ADDENDUM 5

DATE: December 27, 2017

Contract 17-C-00039; Breckenridge Pumping Station Rehabilitation

BRECKENRIDGE PUMPING STATION REHABILITATION
 PROPOSED SECTION D-D

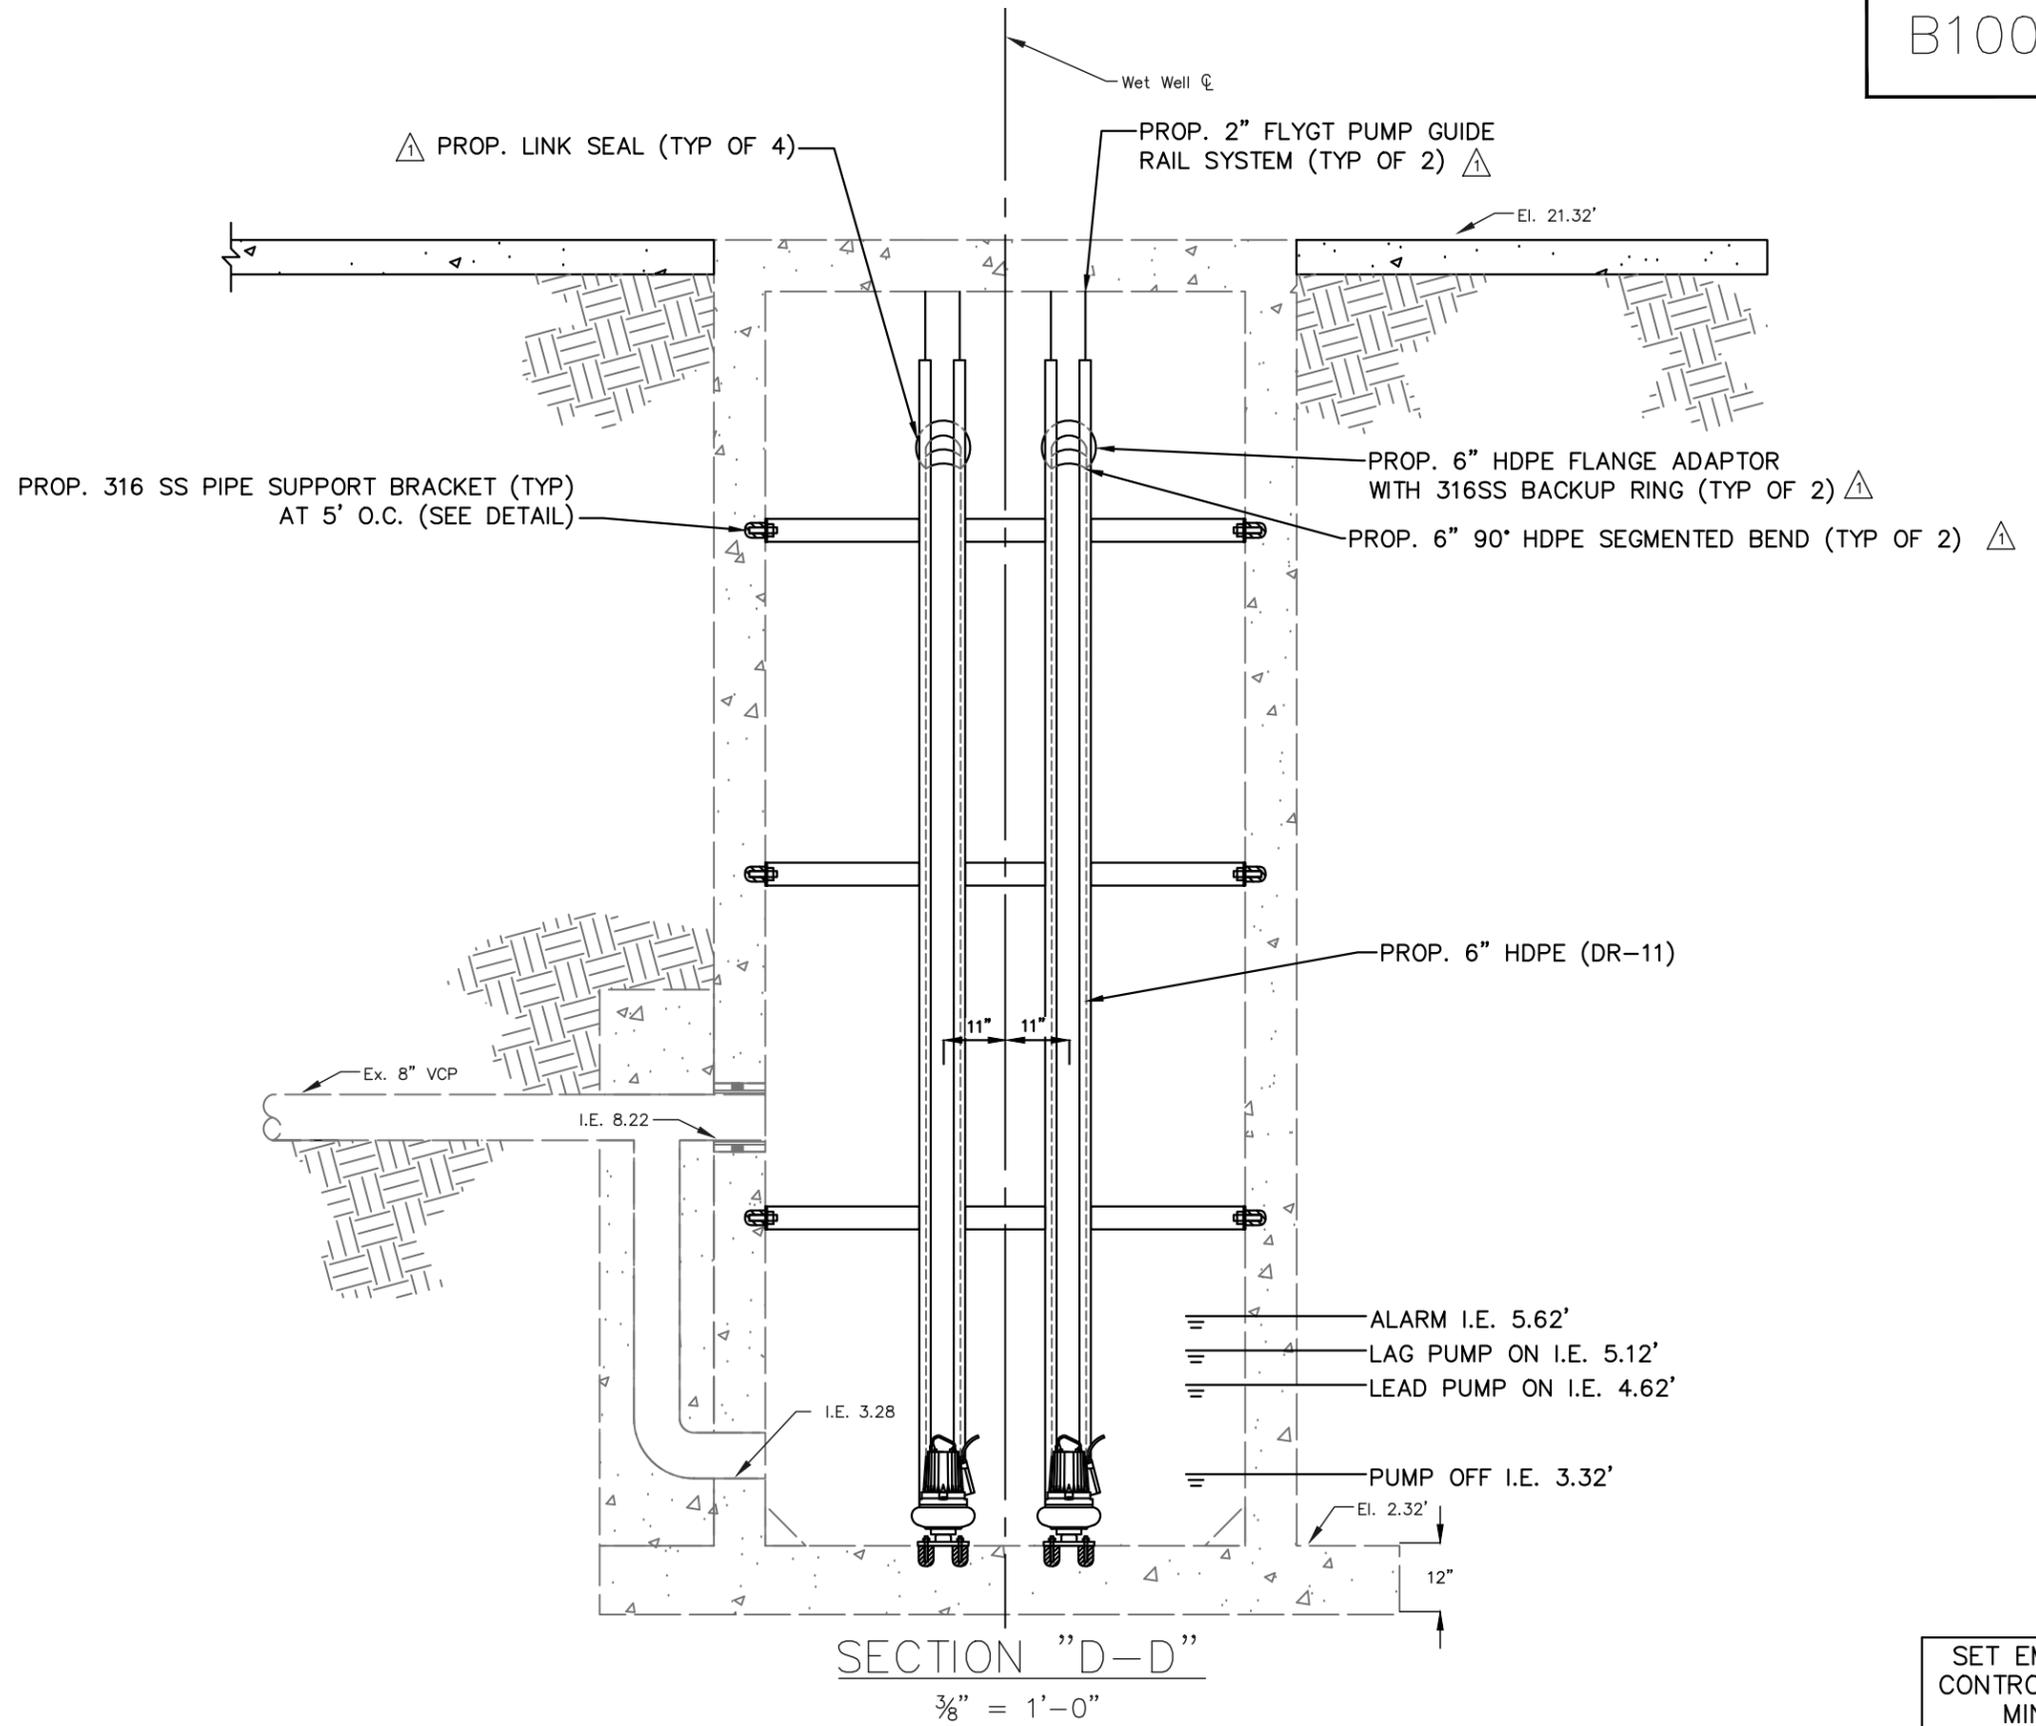
No.	DATE	REVISIONS
3		
2		
\triangle 1	11/7/2017	VARIOUS CHANGES FROM MOVING VALVES INTO VALVE VAULT

SET EMERGENCY CONTROLLER TO 5 MINUTES.

SHEET
E1

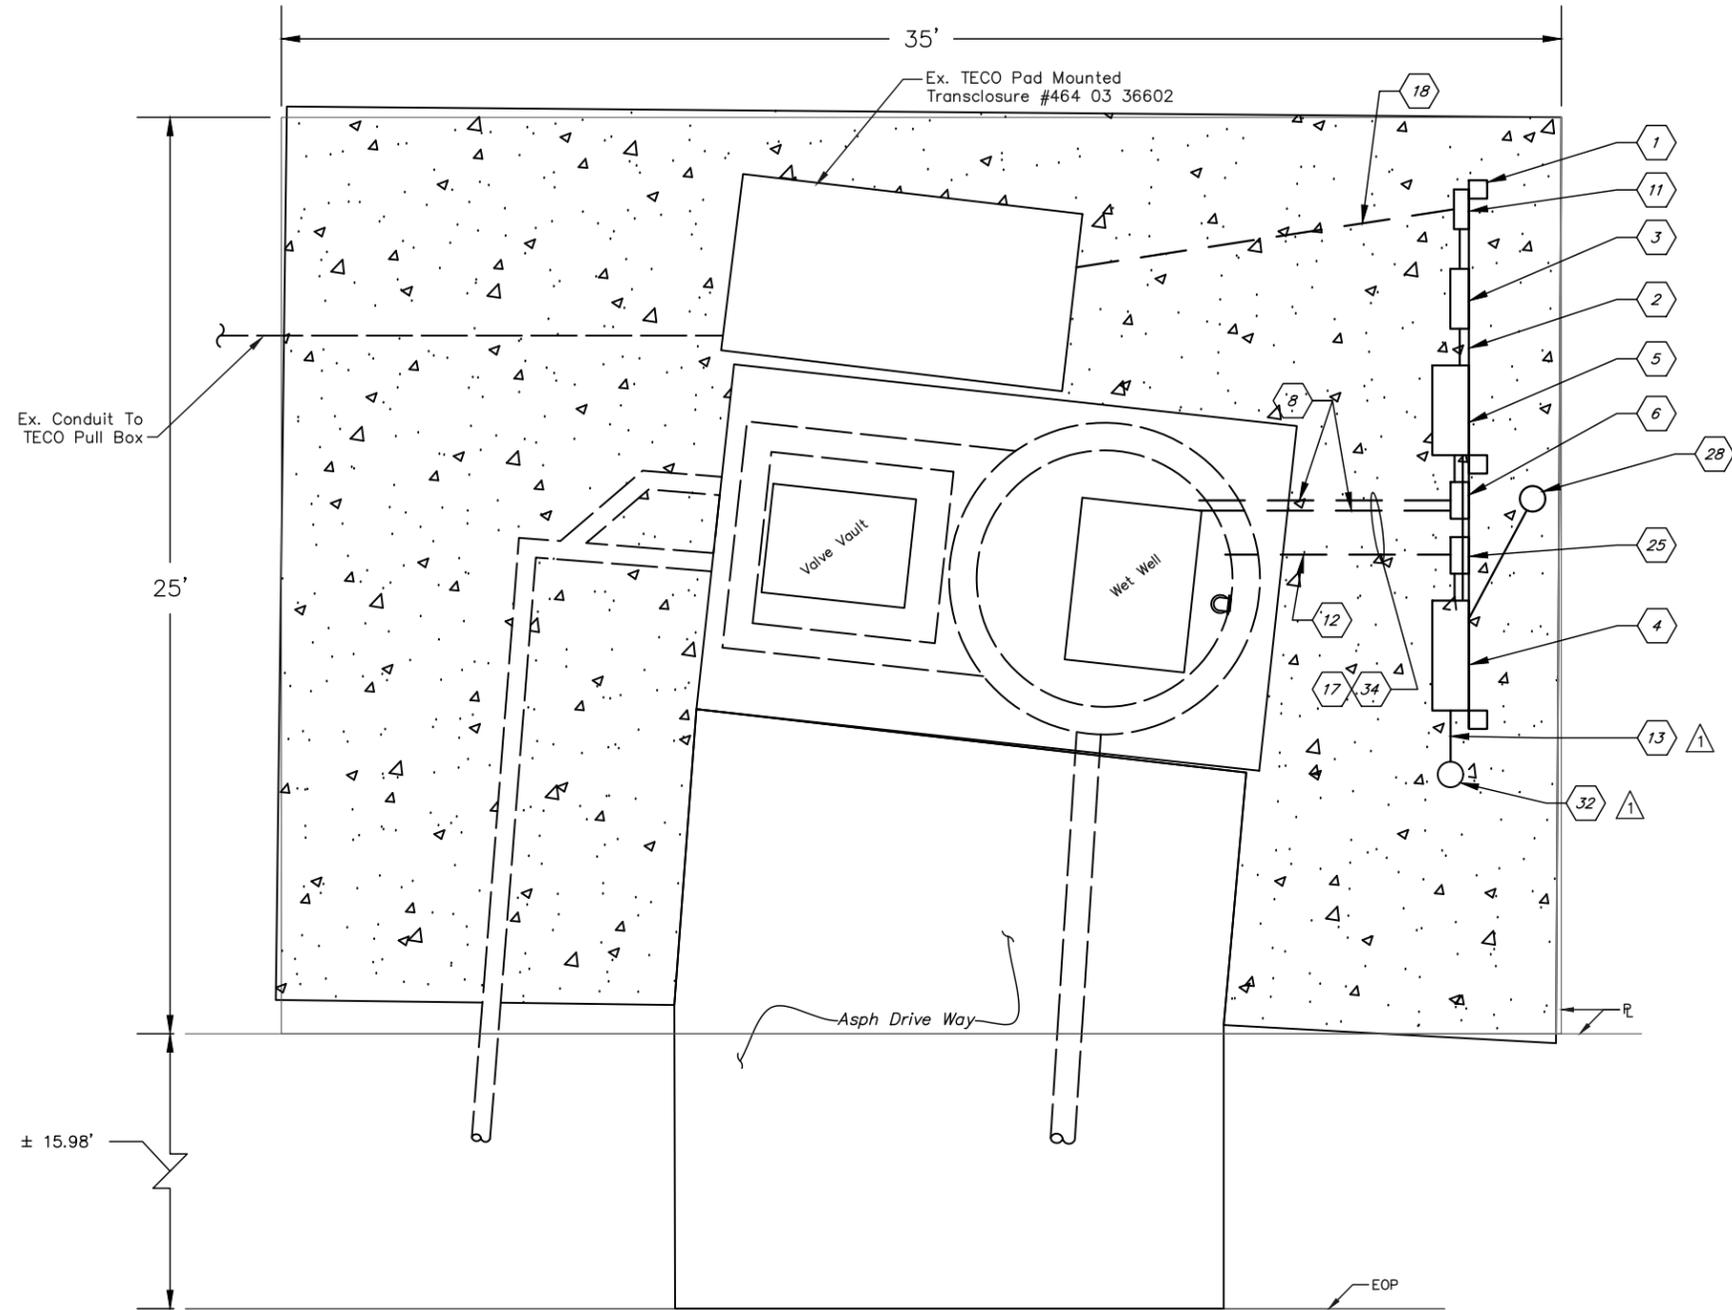
No.	DATE	REVISIONS
3		
2		
1	11/13/2017	RELOCATED SCADA ANTENNA

SHEET
E17A

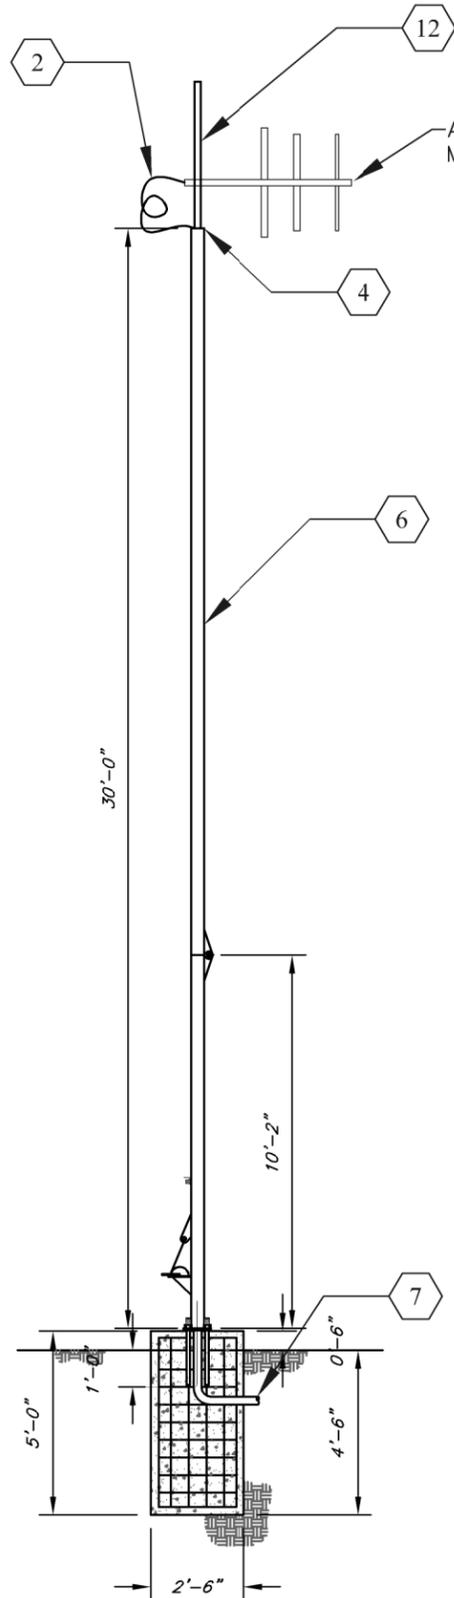
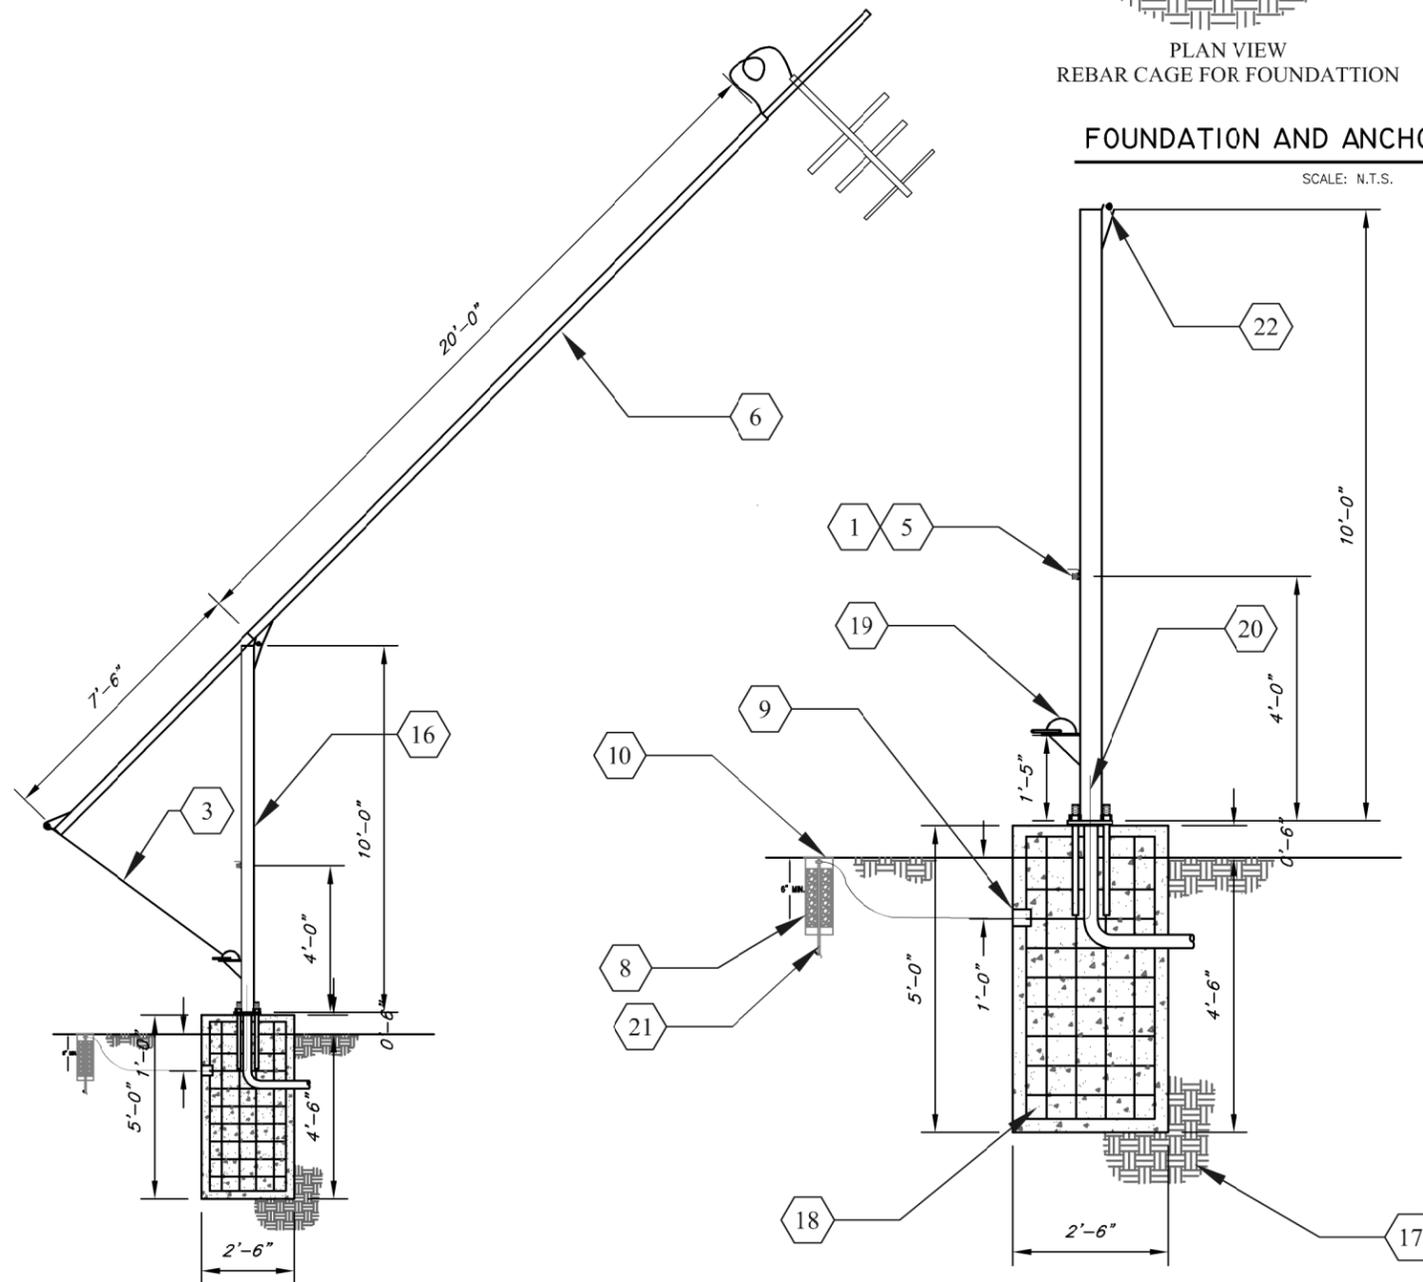
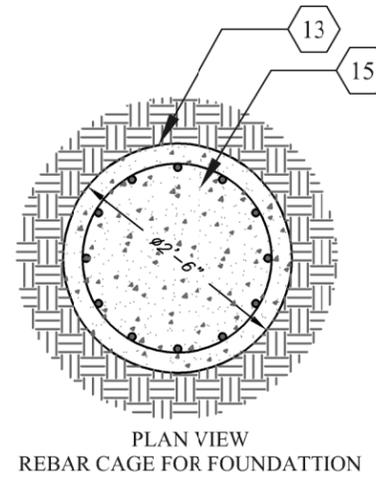
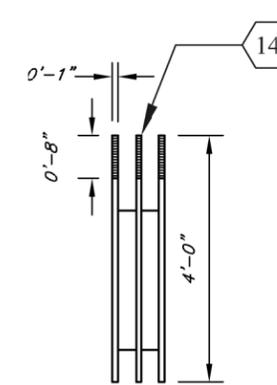
No.	DATE	REVISIONS
3		
2		
1	11/13/2017	ADDED SHEET

- ⚠ ㉜ PROPOSED SCADA ANTENNA WITH HINGED POLE. CONTRACTOR SHALL INSTALL HINGED POLE WITH POLE ASSEMBLY LOWERING TOWARDS THE ASPHALT DRIVEWAY.
- ㉝ CLAMP GROUND WIRE TO METAL WATER PIPE.

- EXISTING ANTENNA/MAST SHALL BE CAREFULLY REMOVED AND DELIVERED TO THE HOWARD F CURREN WASTEWATER TREATMENT PLANT AS INVENTORY.
- PROVIDE AND INSTALL A NEW GREATER PLAINS TOWER MID HINGED POLE PACKAGE. THE HINGED POLE PACKAGE SHALL INCLUDE:
